This document is not a comment on the merits and quality of the architecture of the proposed house, but on how it fits into the associated streetscape and into the Heritage Conservation District.

According to the HCD plan Bylaw, Grade I homes on the associated streetscape mandate the parameters of acceptable new construction. **Grade I homes are the limiting factor.** There are various Grade I homes on the associated streetscape of Juliana Road: 55,60, 80,100,142, 150, and 175. The current proposal has not taken sufficient account, if any of these homes. It is not enough to compare other non-Grade I properties on the associated streetscape to analyse the siting in relation to the setbacks. The following are photos of the Grade I homes. All with generous front yards and many with wood siding.

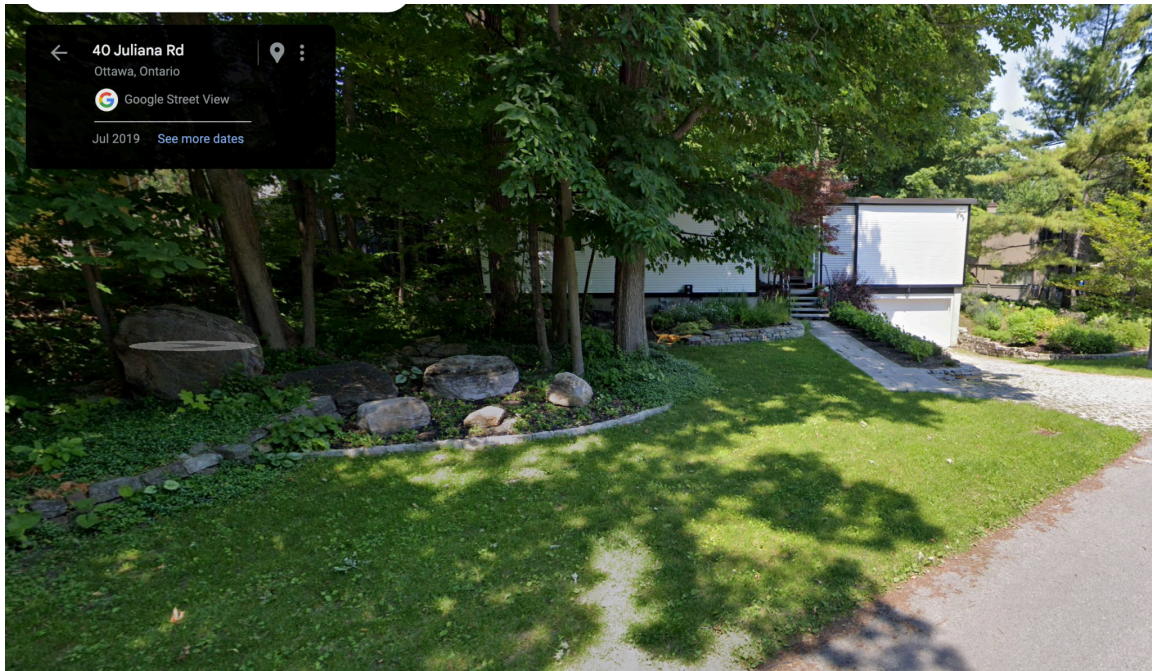
The proposed project **pushes the Zoning Bylaw to the limit** in terms of the side and rear yard setbacks, the FSI, and the lot coverage. See table below

A Heritage bylaw is enacted to protect the attributes and characteristics of a Heritage Conservation District. The Heritage Bylaw **is a higher standard and should provide protection beyond the minimum of the Zoning Bylaw.** Generally to be heritage friendly, proposals should do more than meet the minimum ZBL.

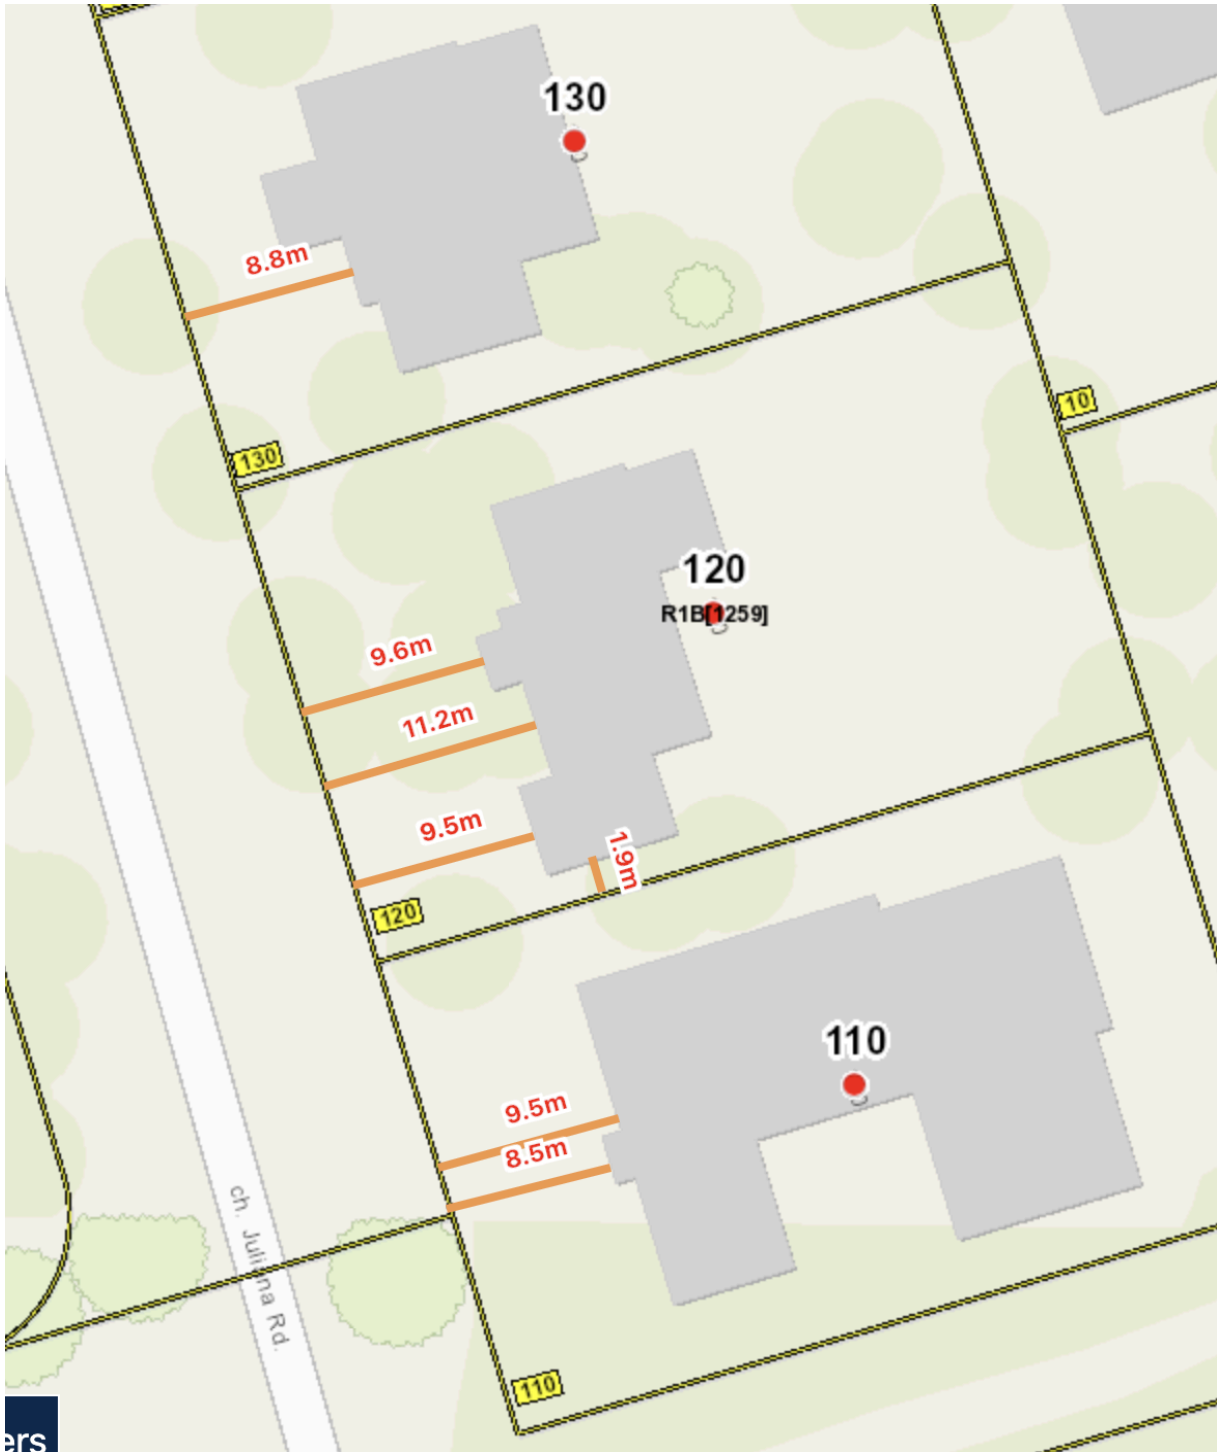
This proposal is set closer to the road than the original and the adjacent properties and **the current front yard setback is not preserved.** The existing home has an average setback of 10m . While the proposed 8.2m setback is an improvement on the original proposal of 6m and the 4.5m minimum under the ZBL, the proposed house is set closer to the road than

- i) the existing original, than
- ii) the adjacent neighbours and
- iii) more than half of the Grade I homes on the associated streetscape.

This decreased setback has a negative effect on the associated streetscape by bringing the mass of this house closer to the road, therefore encroaching on the greenspace of the public realm. The setbacks should be increased to comply with the Heritage bylaw.

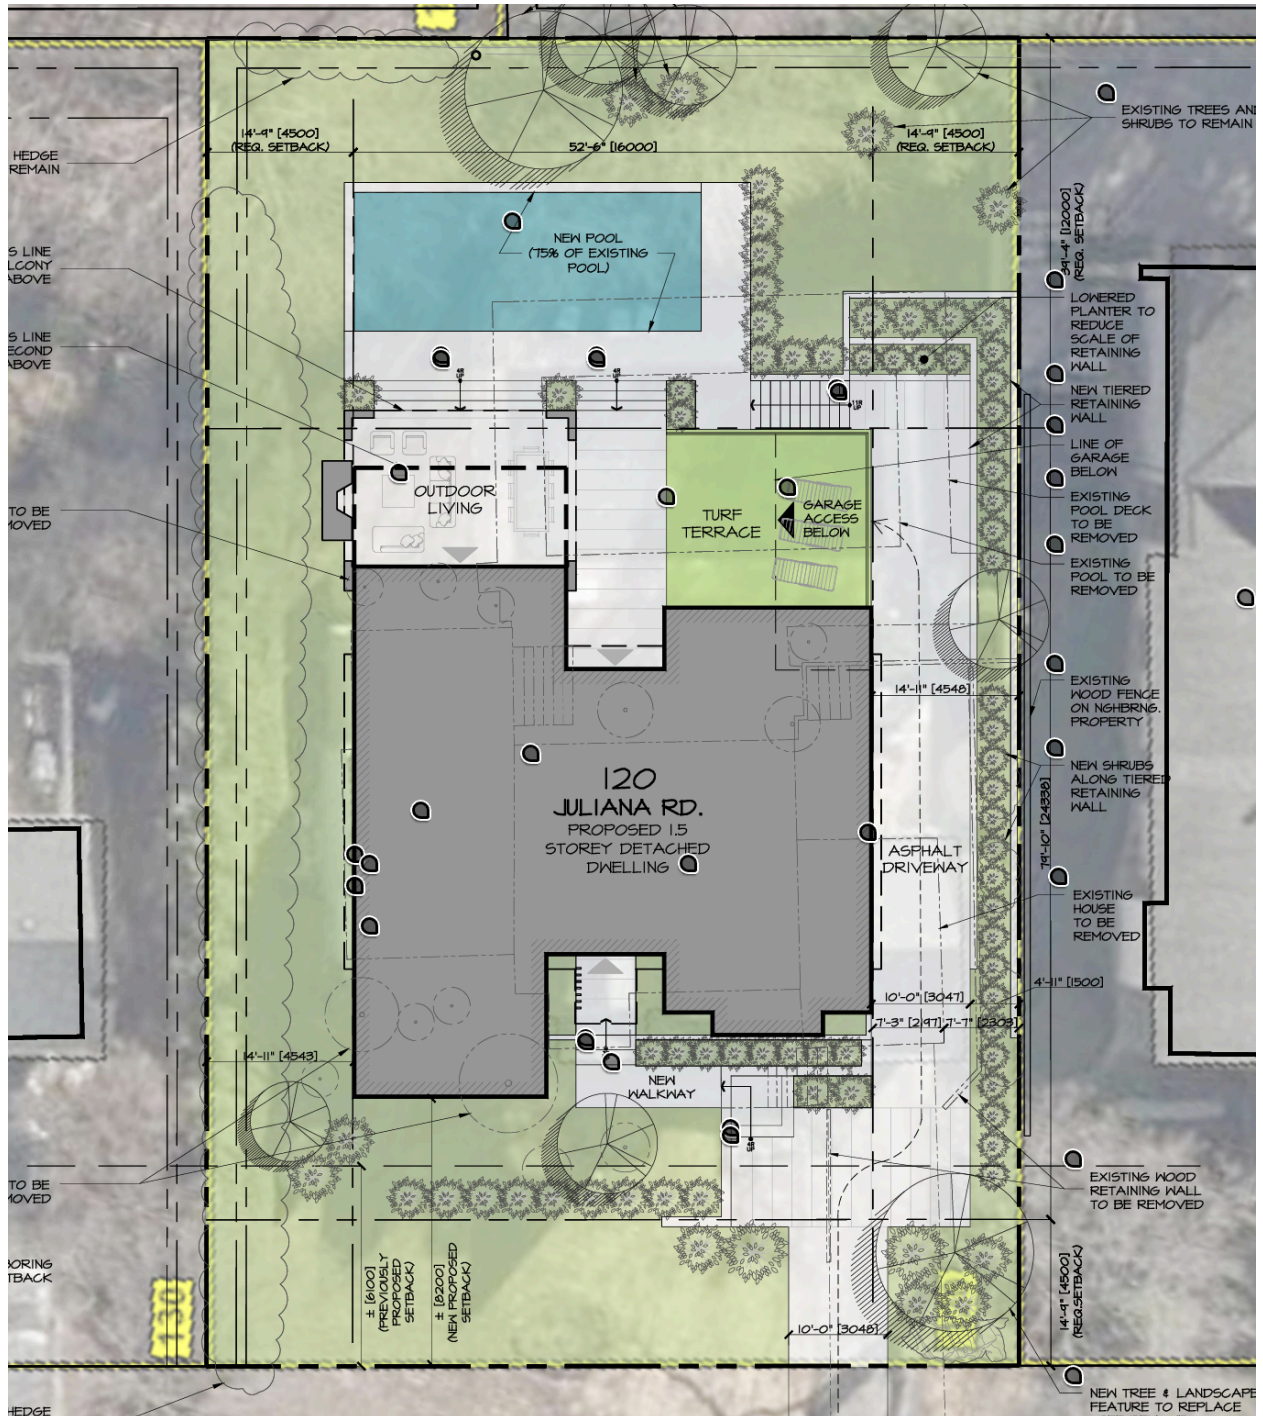
Aside from the space occupied by the building, the soft landscaping does not dominate the remaining property. Much of the green landscape is taken up by the

hard landscape of the pool and terraces. The “green turf” material is not specified, but could be interpreted as an artificial covering and not green scape.
